Dear Dennis,

Thanks for your comments. Here are our answers:

ANS 2: As Form 731 & Test report indicated, the EUT is a Wireless LAN module (MPCI3A-20/R).

Please see following photos

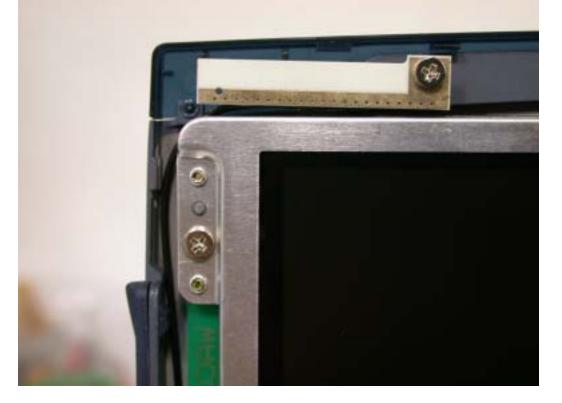
ANS 5: .The antenna fits into the bottom of the LCD Screen is AUX antenna. The AUX antenna is working as the receiving antenna. And, the antenna fits into the top of the LCD Screen is MAIN antenna, which is working as the transmitting & receiving antenna. Why do that? Just for Antenna Diversity. The transmitting antenna can affect the body, but the receiving antenna isn't. The distance from the body should be considered as the distance between the main antenna and the body. This distance from the top antenna to the body is more than 20cm, and we need MPE not SAR.

(The black wire is connected the Main connector, and the white wire is for the AUX connector.)

(The white wire (AUX) is connected to the bottom antenna)

(The black wire (MAIN) is connected to the top antenna.)

(The top antenna (main antenna) is more far away the body than 20cm.)
